#### PUBLIC HEARING/WORKING SESSION MEMORANDUM

PETITION #69-14 79 Shornecliffe Road

Request for Special Permit/Site Plan Approval to allow a retaining wall greater than four feet in the rear setback, at 79 Shornecliffe Road.

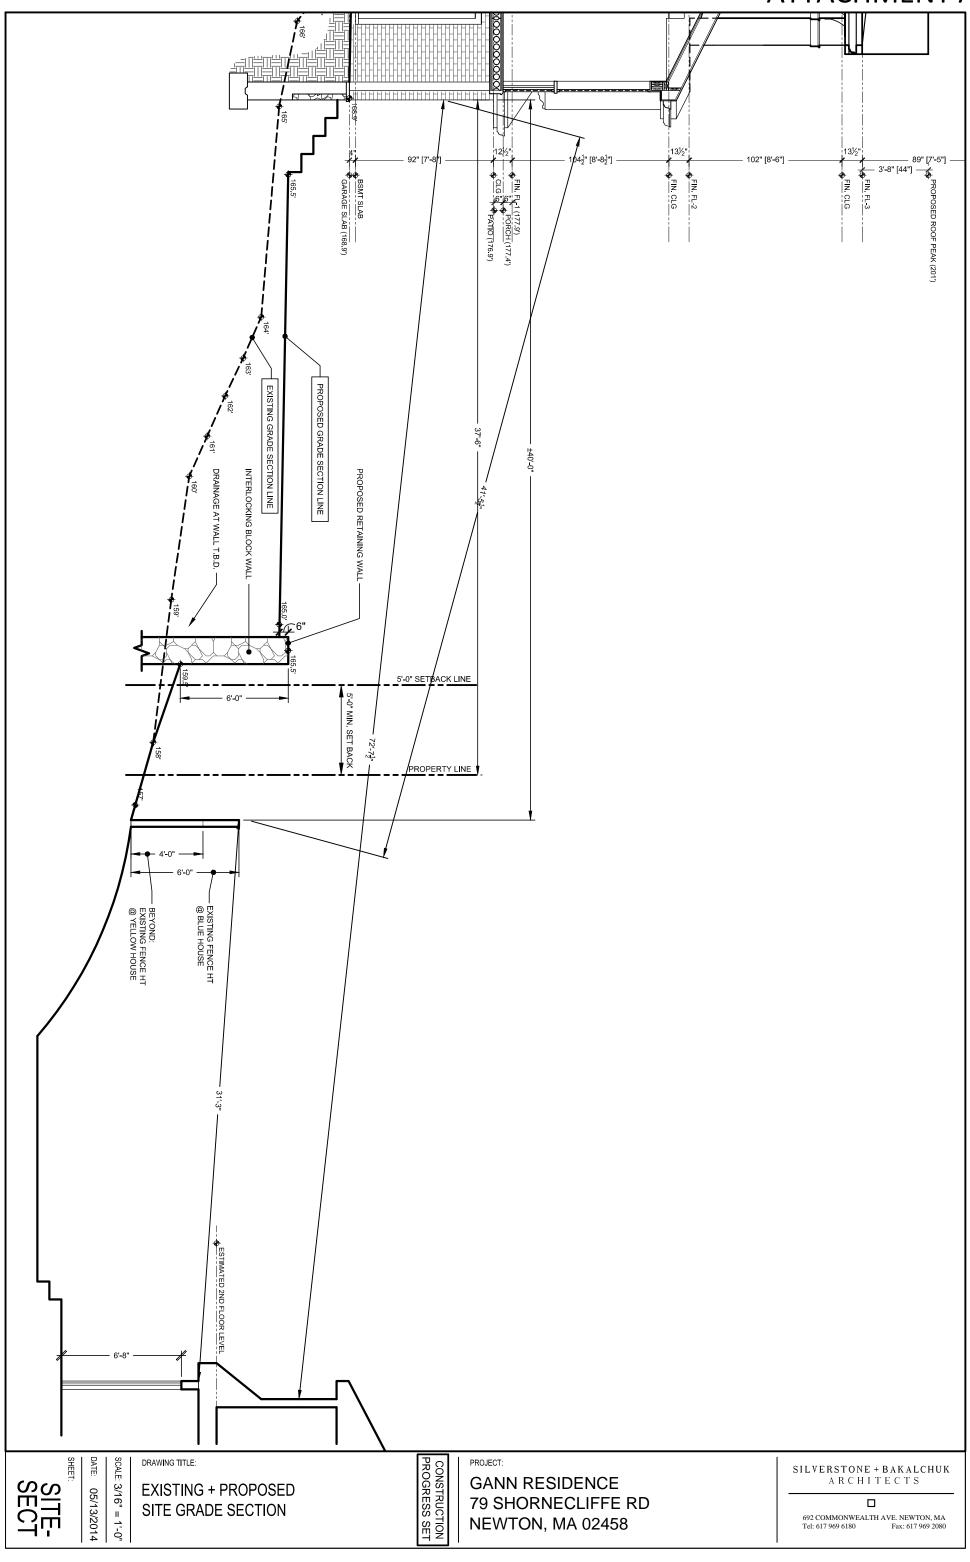
The petitioner's architect provided a cross-section showing the view of the proposed retaining wall from the rear of 96 Nonantum Street and 100 Nonantum Street. The cross-section assumed no vegetation on the site. The petitioner also constructed an approximately ten foot wide mock-up of the proposed retaining wall on the site, to physically illustrate its approximate height. It appears that approximately two feet of the retaining wall will be visible from the rear yard of 96 Nonantum Street, and that approximately five feet will be visible from the rear yard of 100

Nonantum Street. The proposed retaining wall will be mostly visible from the second story of the abutting properties.
